Rozelle Village

COUNCIL RFI RESPONSE TABLE

135 - 152 Victoria Road, Rozelle

20220063-AR-DA002 Revision [A] - 17 MAY 2023

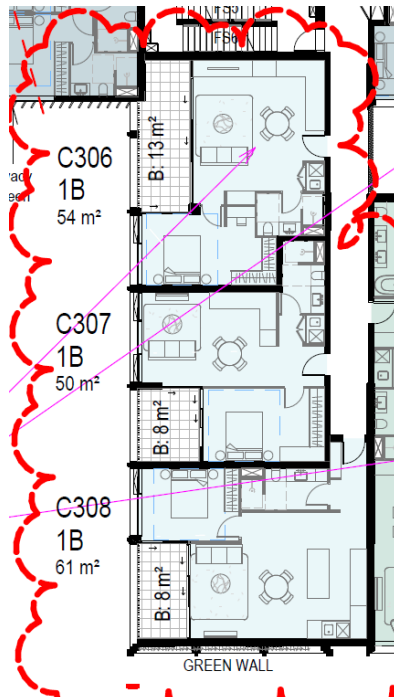
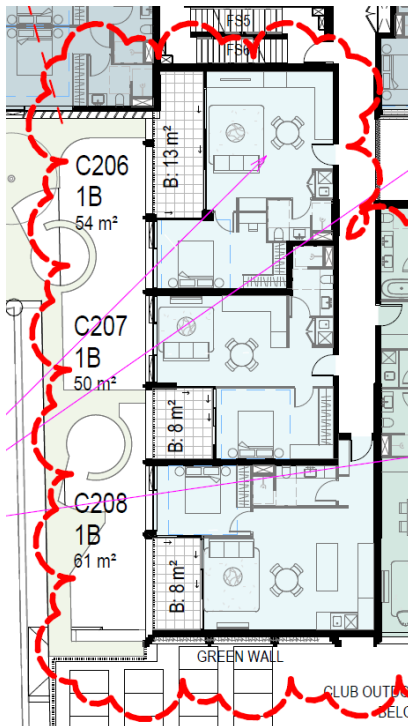
Council RFI Received 28 th April 2023 - Response Table			
Item	Panel Comments	Response/Resolution	Achieved
01. Design changes required	<p>b. Reintroducing some form of stronger horizontal expression would be appropriate to the residential nature of this building and would also assist with the balance of horizontal and vertical elements within the overall building composition. Such a strategy should also consider the management of built form and scale from Victoria Road viewpoints</p>	<p>Horizontal expression has been strengthened in the facade articulation by increasing depth and size of horizontal elements. In order to maintain appropriate facade proportion and modulation the horizontal elements have been balanced so as not to dominate the overall expression.</p> <p>Plaza Side Buildings - Additional horizontal treatment has been added at every level to the plaza side facades, this approach reduces the 'double height' facade articulation in the existing S4.55 design, and strengthens the horizontal expression whilst complementing the overarching design intent.</p> <div>   </div> <p>Victoria Road Buildings - Additional horizontal treatment at every level to the facades fronting Victoria Road is not a desirable outcome. The existing double height expression in the current S4.55 design create slightly taller and more slender forms, an appropriate urban design response to the large arterial road and surrounding fabric that these facades address.</p>

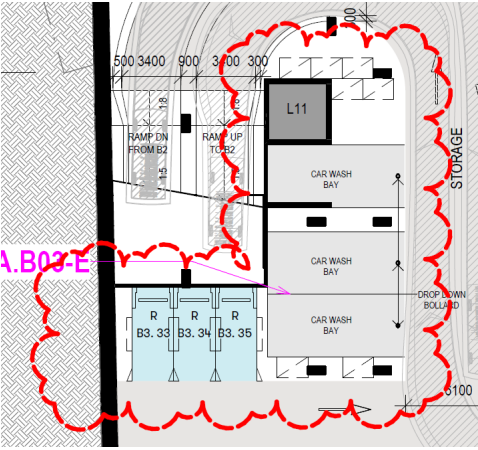
Council RFI Received 28 th April 2023 - Response Table			
Item	Panel Comments	Response/Resolution	Achieved
01. Design changes required	<ul style="list-style-type: none">01C(C) Potential inter-tenancy privacy issues between the master bedrooms of typical apartment B102 and the balconies of typical apartment B103 should be resolved. The Panel is concerned that privacy screens alone are unlikely to resolve acoustic privacy issues due to the adjacencies.01C(D) Although not specifically discussed at the meeting, residential storage volumes for all apartments should be confirmed in terms of consistency with Part 4G of the NSW ADG.01C(E) There are potential privacy issues at the re-entrant corner where typical apartment C107 is located. The bedrooms and balconies are in close proximity to the common corridors and reconfiguration is recommended to avoid visual and acoustic privacy issues. The outlook of bedrooms from typical apartment C207 into a blank wall should also be reconsidered.	<p>01C(C) SC has amended this arrangement in DD. Updated arrangement can be provided. The design uses double glazing to meet acoustic, visual and thermal performance requirements.</p>  <p>01C(D) We confirm that all ADG residential storage requirements are met or exceeded in the design. An additional drawing (AD-DA615) has been provided in the revised S4.55 drawing set that outlines these storage volumes and compliance.</p> <p>01C (E) Privacy screening and elevated planting has been utilised to ensure adequate privacy has been achieved. The proposed arrangement is an improved condition compared to the Approved DA design and provides improved amenity and outlook.</p> <div><div><p>Approved DA</p></div><div><p>S4.55</p></div></div>

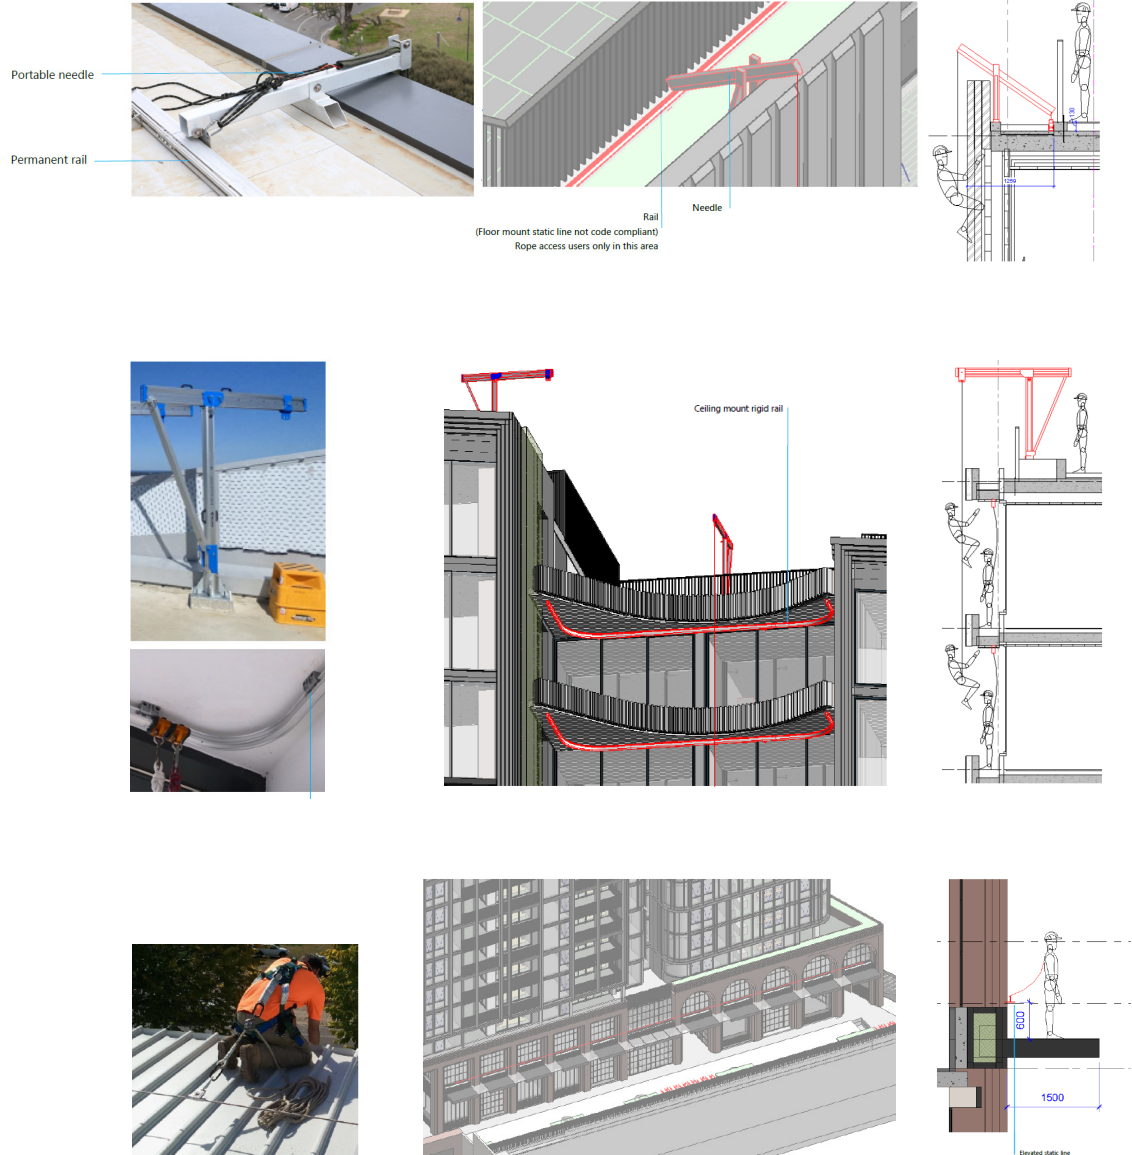
03. Shadow diagrams that demonstrate the differences between approved development and proposed modifications.	<p>a. Additional shadows are requested to indicate the difference between the approved development and proposed modification. This is to identify what the additional impacts (if any) there are in comparison to the approved development.</p> <p>It is requested that shadow diagrams are provided in plan and elevation view of existing and proposed overshadowing for 21 June and equinox at hourly intervals between 9am and 3pm. It is requested that a table identifying the approved and proposed outcomes is provided to each affected property.</p>	<p>Additional shadow diagrams have been provided in the amended drawing set.</p> <p>The shadow diagrams identify improved or neglible additional shadow impact to the surrounding context over the aapproved DA scheme.</p>
